ITEM: 6.9	COMMITTEE OF ADJUSTMENT REPORT SUMMARY MINOR VARIANCE APPLICATION FILE NUMBER A245/22 623 PLEASANT RIDGE AVE, THORNHILL
------------------	--

**COMMITTEE OF ADJUSTMENT REPORT
MINOR VARIANCE APPLICATION
A245/22
623 PLEASANT RIDGE AVE, THORNHILL**

ITEM NUMBER: 6.9	CITY WARD #: 4
APPLICANT:	Maxim and Jennifer Marants
AGENT:	None
PROPERTY:	623 Pleasant Ridge Ave, Thornhill
ZONING DESIGNATION:	See below
VAUGHAN OFFICIAL PLAN (2010) DESIGNATION:	Vaughan Official Plan 2010 ("VOP2010"): "Low-Rise Residential"
RELATED DEVELOPMENT APPLICATIONS:	None
PURPOSE OF APPLICATION:	Relief from the Zoning By-law is being requested to permit an existing unenclosed porch/deck.

PLAN

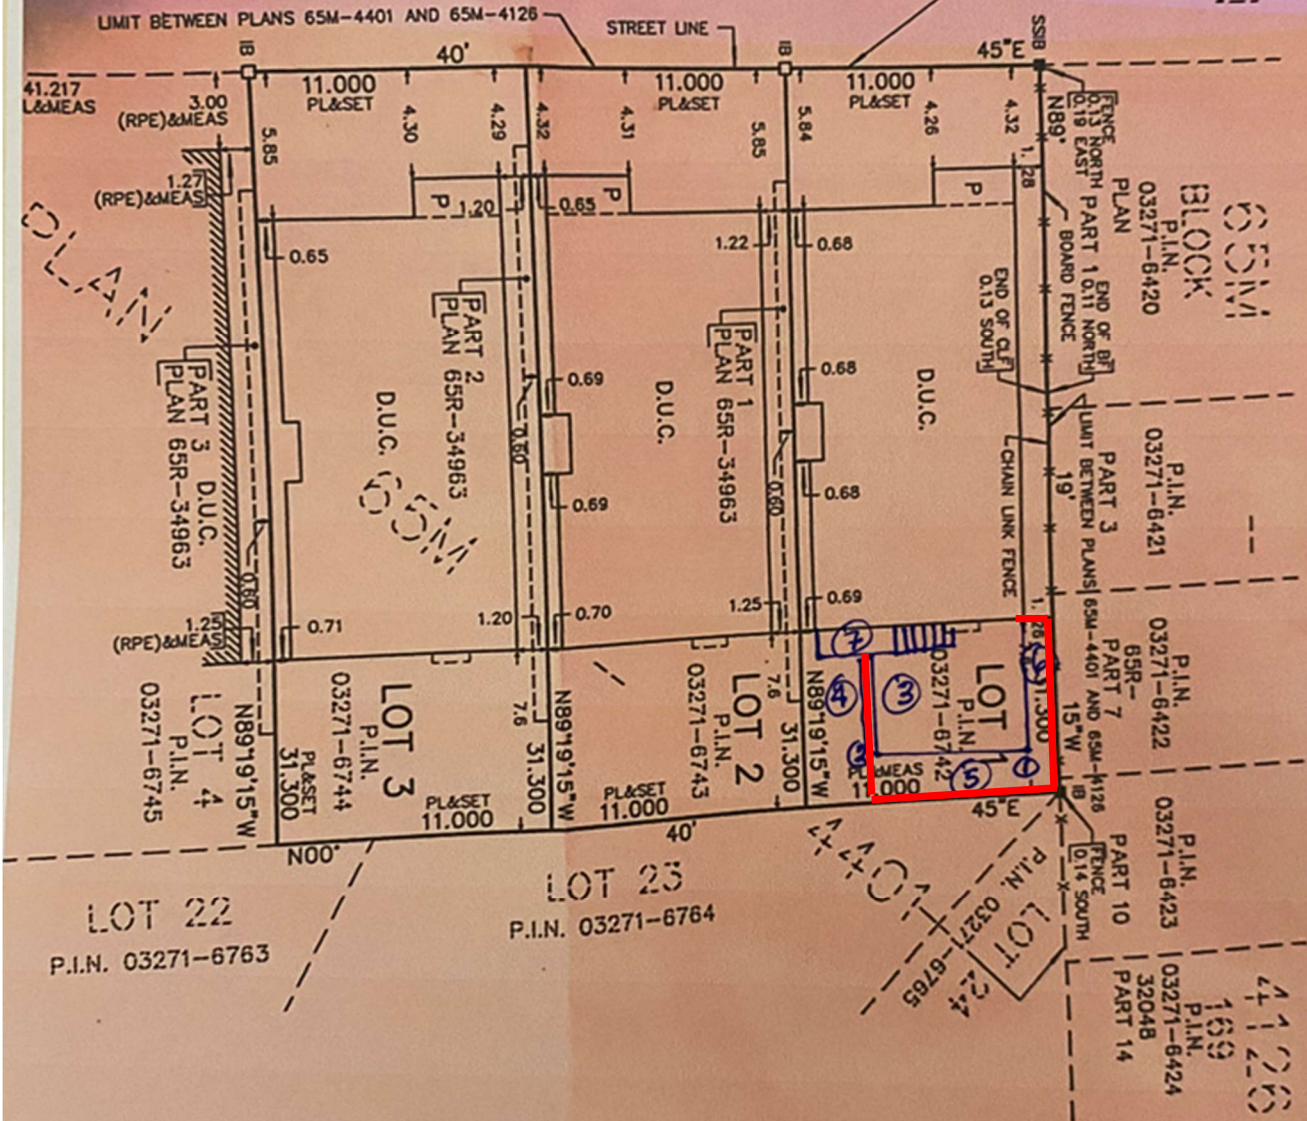
The proposed deck will not be constructed on grade. Therefore there will be no impacts to the existing drainage patterns on the property.

Planning staff conducted a site visit on February 6, 2023, which confirmed a rear yard deck existed on-site. The existing uncovered deck provides very modest rear and northerly interior side yard setbacks. The Owners, in consultation with Development Planning, have decided to propose a new deck with a smaller footprint with increased setbacks.

The Development Planning Department has no objection to the variances, as the proposed rear yard deck (uncovered platform) is in-line with the north wall of the dwelling and complies with minimum side yard setback requirement of the By-laws. The abutting rear yard to the east has a hedge along the mutual rear lot line, and the dwellings to the east are spaced and oriented away from the deck. Sufficient space is maintained from the north lot line for the separation of uses between the proposed deck and abutting rear yards and for the establishment of vegetation to increase privacy. Due to the above analysis, Development Planning and Development Engineering are of the opinion there will be no negative massing, use, or drainage impacts.
